H. L. Sumner, Jr.  
Vice President  
Hatch Project

NL-05-1362

Edwin I. Hatch Nuclear Plant  
Supplement to Technical Specifications Revision Request to  
Standby Liquid Control Figure 3.1.7-1

### Edwin I. Hatch Nuclear Plant Supplement to Technical Specifications Revision to Standby Liquid Control Figure 3.1.7-1

Figure 3.1.7-1 (page 1 of 1)  
Sodium Pentaborate Solution Volume  
Versus Concentration Requirements

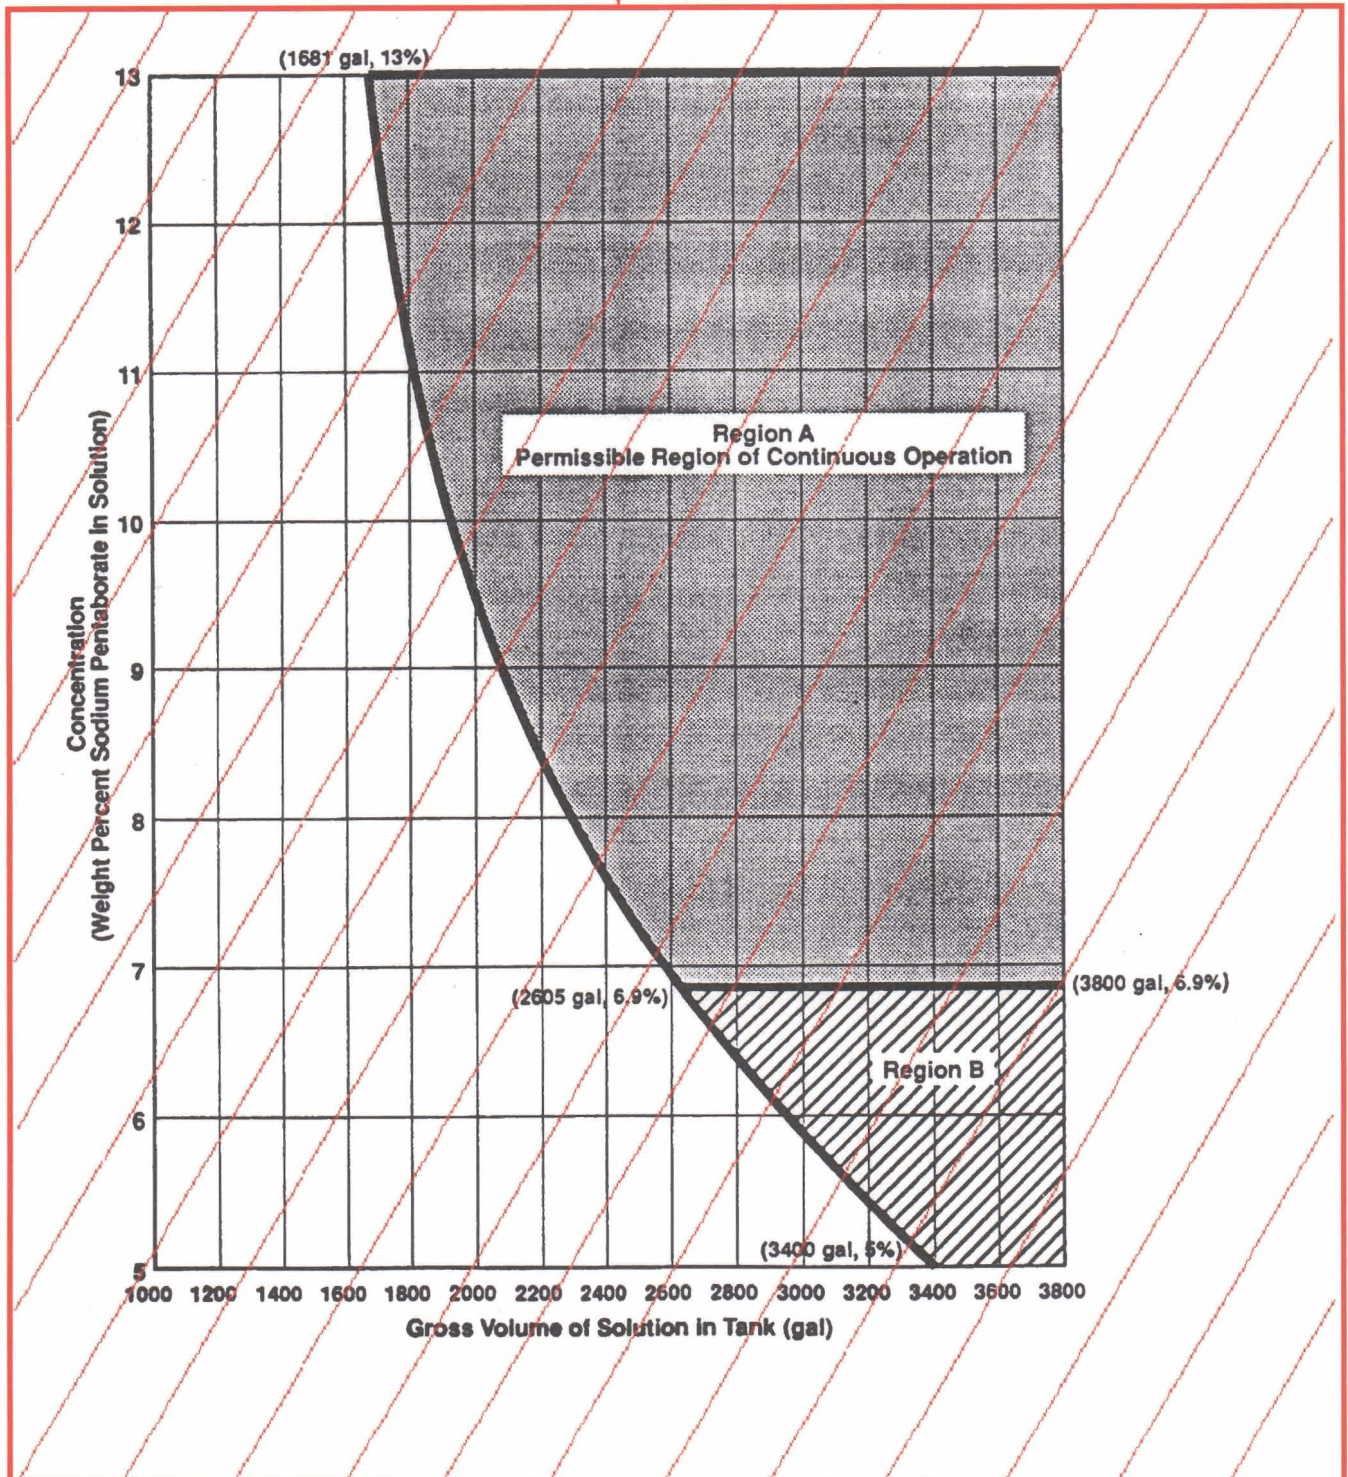
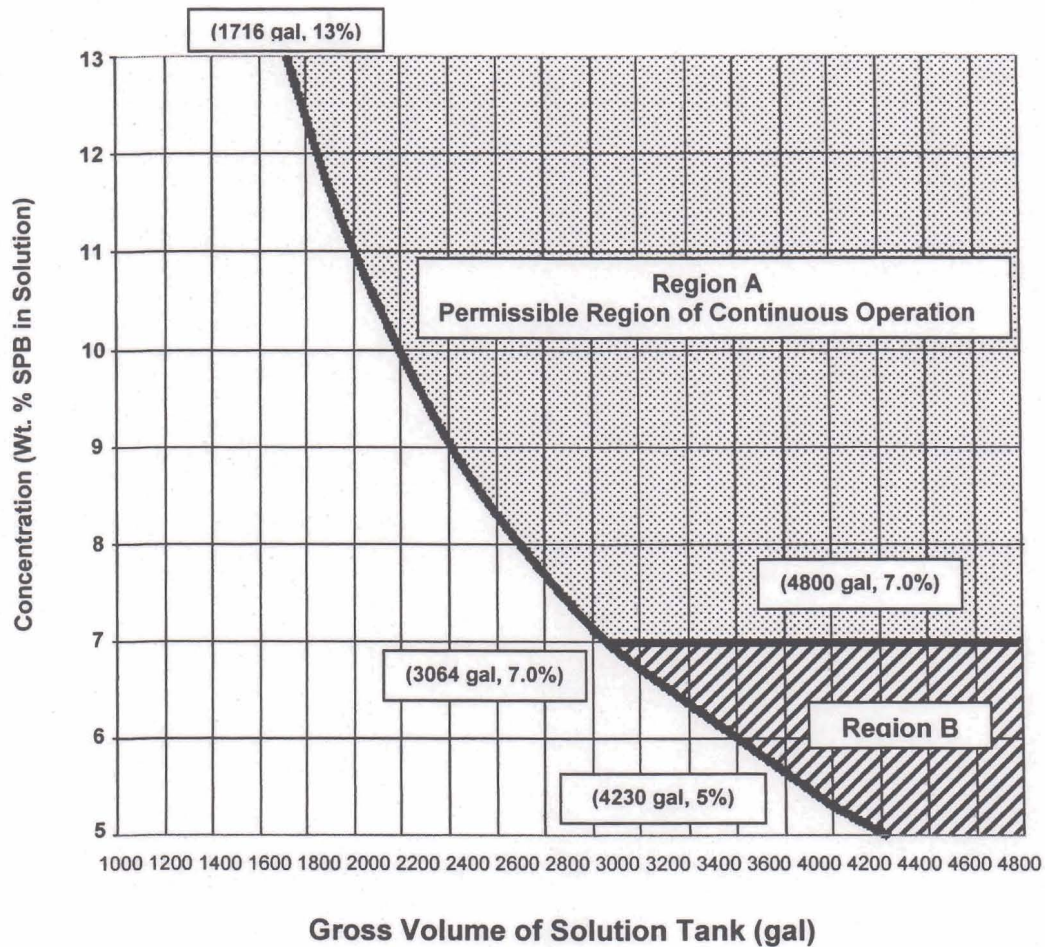
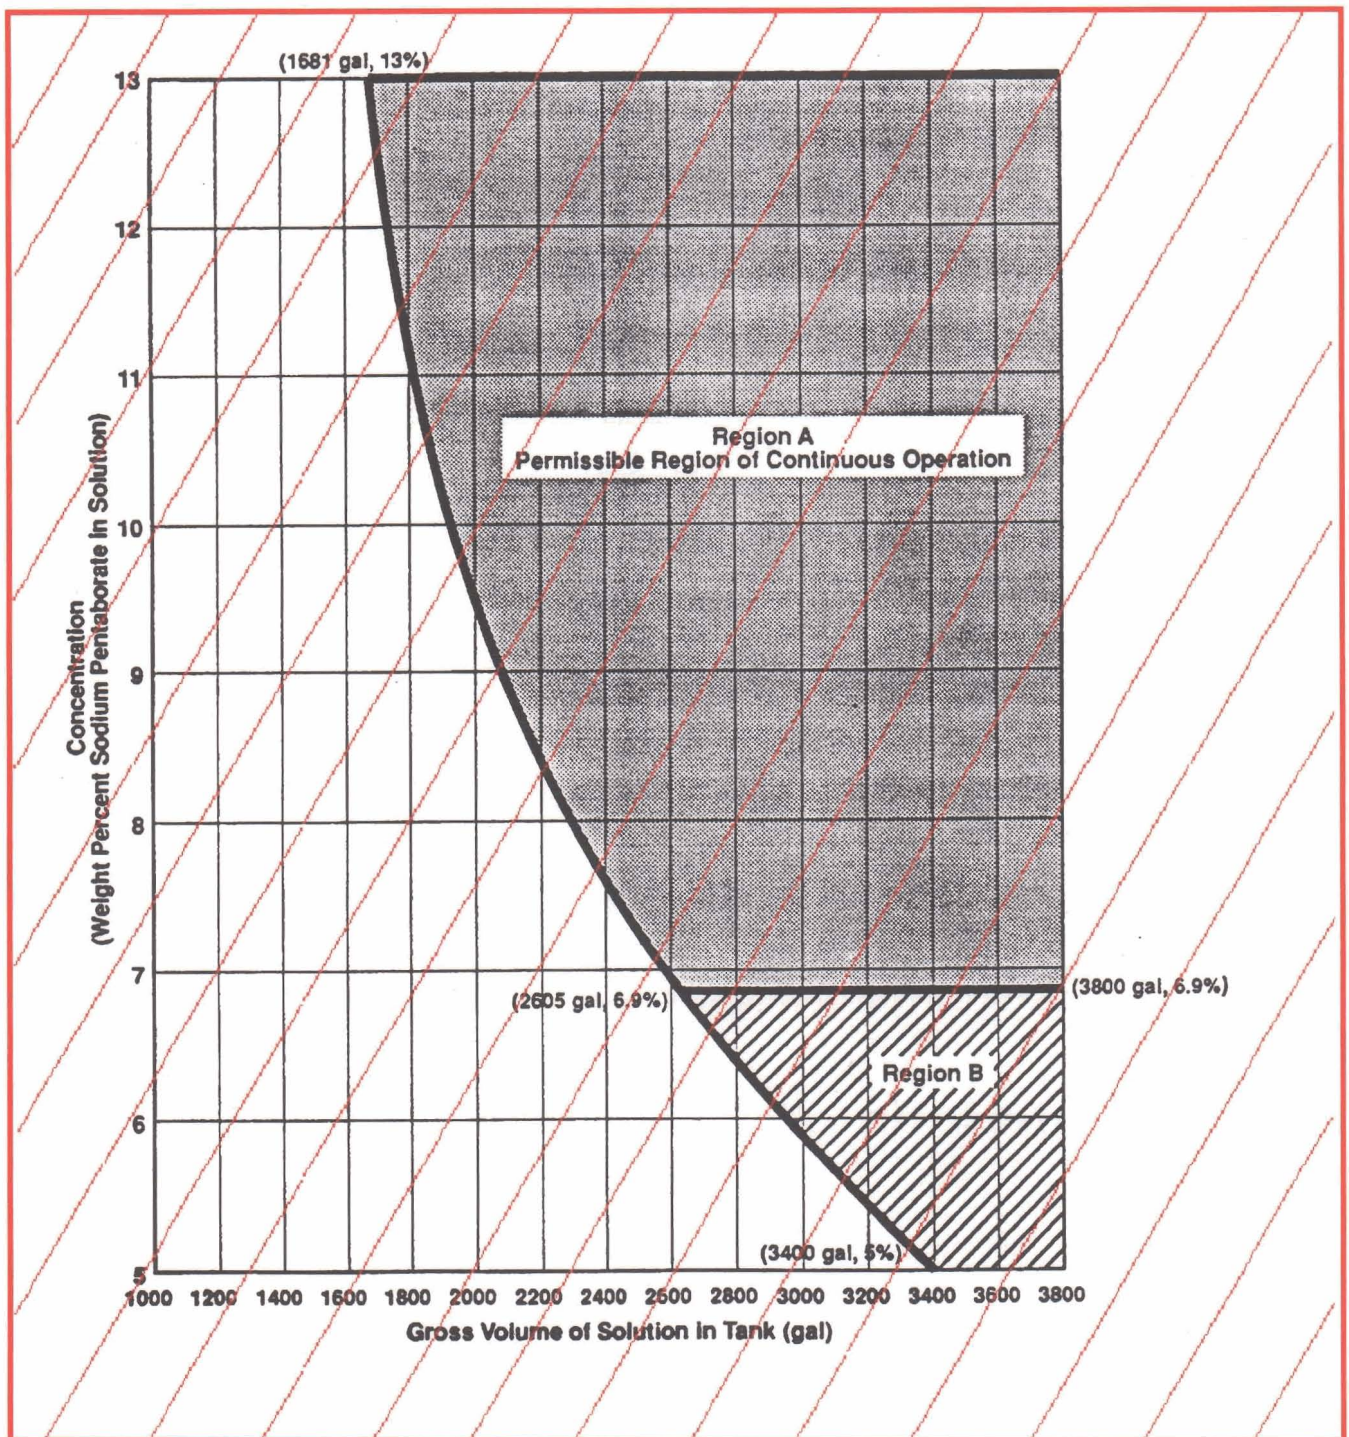
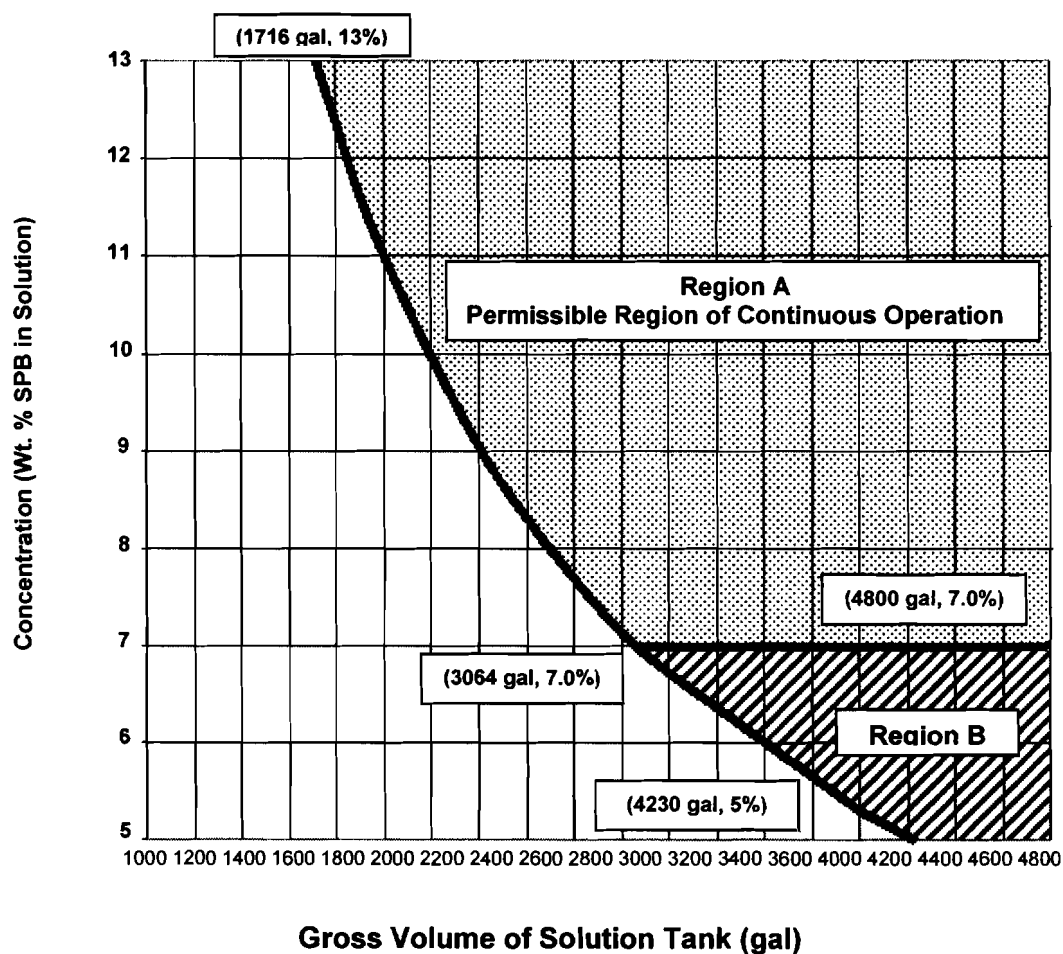
In reviewing the response to a Request for Additional Information on SNC's November 12, 2004 submittal, a round off inconsistency in the translation of the equivalency determination calculation into the current TS Figure 3.1.7-1 was noted. To eliminate that inconsistency, SNC proposes to change the minimum concentration of sodium pentaborate as depicted in both Figures 3.1.7-1 and 3.1.7-2 from 6.9% to 7.0%.

A round off inconsistency was discovered between the existing calculation of the Plant Hatch equivalency determination and the translation of that data into the current Figure 3.1.7-1. To avoid that inconsistency in the new figure, SNC is revising the proposed Figure 3.1.7-1 to increase the minimum concentration from 6.9% to 7.0%. This also represents the boundary between Region A and B. The boundary between these regions is also provided in Figure 3.1.7-2, "Sodium Pentaborate Solution Temperature versus Concentration Requirements". Consequently, Figure 3.1.7-2 is also being revised. The equivalency determination is met as follows:

Figure 3.1.7-1 of the Units 1 and 2 Technical Specifications (TS) is being changed to reflect the increased concentration requirements of Boron-10 that must be injected into the reactor vessel, following an ATWS event, and to increase the minimum concentration of Region A from 6.9% to 7.0%. Figure 3.1.7-2, is also being changed to reflect the increase in the minimum concentration.

The minimum concentration of Sodium Pentaborate which also represents the boundary between Region A and Region B, is changing from 6.9% to 7.0%. This increase in the concentration ensures a conservative margin to the ATWS equivalency determination required by 10 CFR 50.62.

Replace with attached figure
